Agreement No. CE 1/2013 (CE)
 Site Formation and Associated Infrastructural Works for Proposed Development of
 Columbarium, Crematorium and Related Facilities at Sandy Ridge Cemetery – Design and Construction
 Conditions and Recommendations - Response

Comments received:	Responses:
<p>(1) From : CEDD Date : 31 May 2016</p> <p>Recommendations of EIA Subcommittee on the EIA report on “Site Formation and Associated Infrastructural Works for Development of Columbarium, Crematorium and Related Facilities at Sandy Ridge Cemetery”</p> <p>The EIA Subcommittee deliberated the EIA report on “Site Formation and Associated Infrastructural Works for Development of Columbarium, Crematorium and Related Facilities at Sandy Ridge Cemetery” on 20 May 2016 and recommended the full Council to endorse the EIA report with the following conditions and recommendations:</p> <p><u>Conditions of Endorsement</u></p> <p>The Project Proponent shall -</p> <p><u>The need for and extent of the road widening works</u></p> <p>(a) In consultation with the relevant government departments, review the need for and extent of the widening of the existing Lin Ma Hang Road and Sha Ling Road with a view to restricting the ca

Seasonal watercourse under viaduct

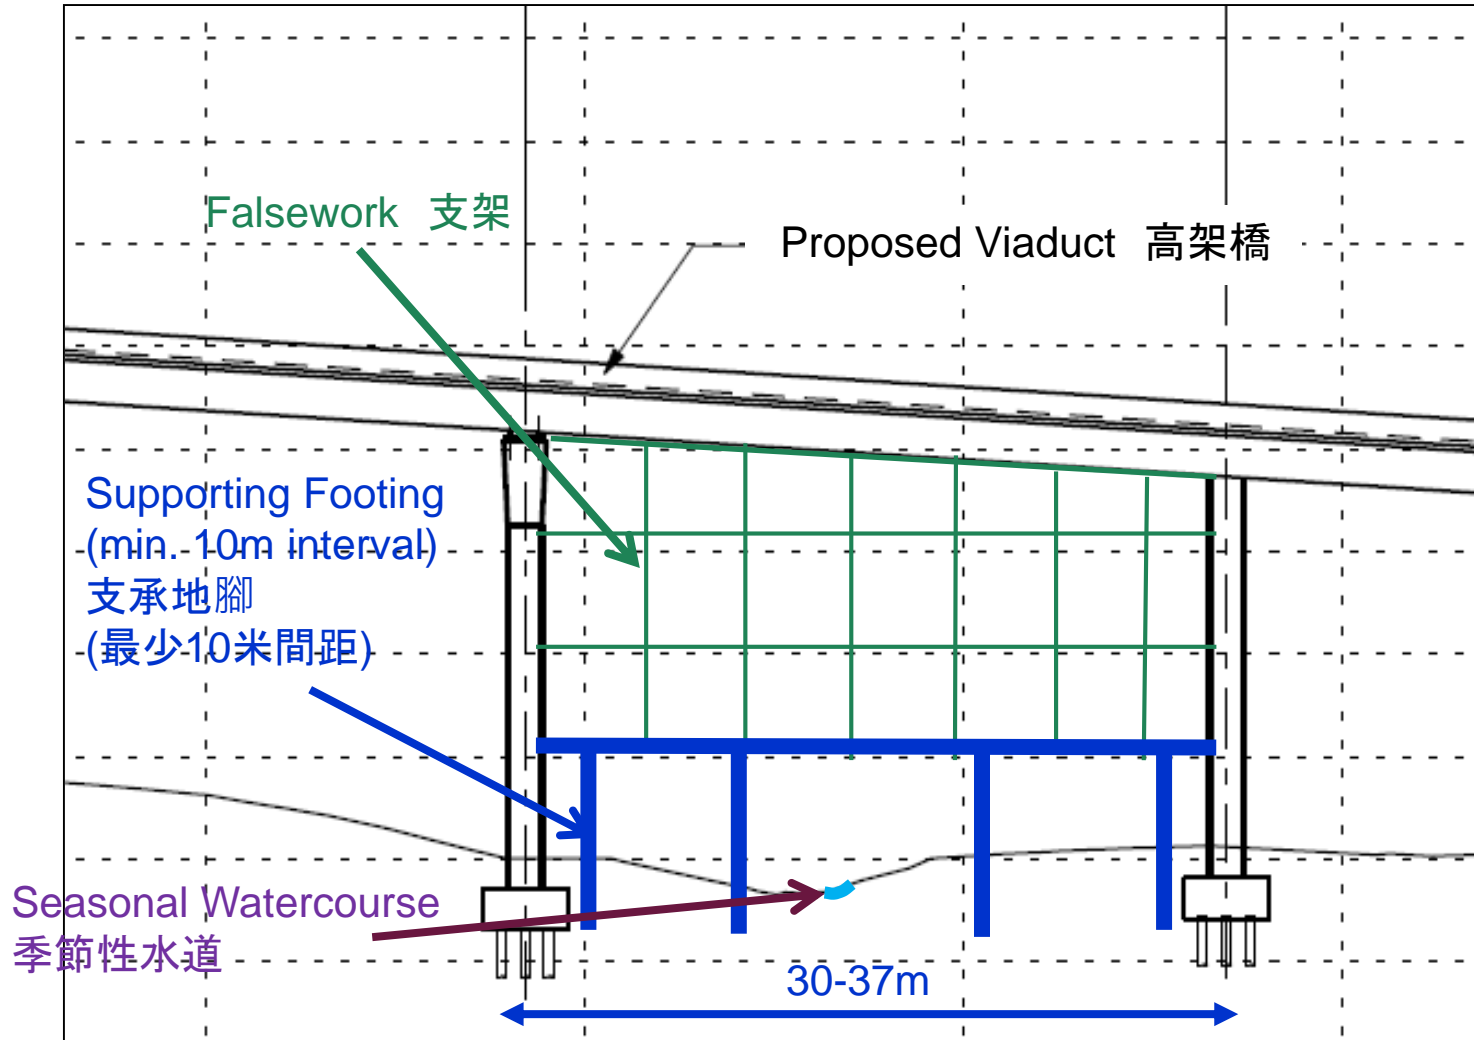
(b)	<p>Alternative methods of design and construction of the viaduct to span across the river course should be used such that no structures, both temporary and permanent, would affect or impact on the water course in the works area.</p> <p><u>Ecological aspects</u></p>	<p>Noted. It should be noted that the design of the viaduct piers has avoided the seasonal watercourse and there will be no encroachment. The seasonal watercourse is shallower in gradient than those running off the hillside. It is largely dry with flows occurring only after periods of sustained rainfall. This seasonal watercourse is heavily vegetated with common herbs, dragonfly and butterfly species. The permanent or temporary works of the viaduct has been and will be designed to avoid the seasonal watercourse. The arrangement and photo of the seasonal watercourse can be referred to Attachment 2.</p>

Footings of the falseworks will be designed to avoid encroachment on the watercourse
支架的地腳設計會避免侵入水道
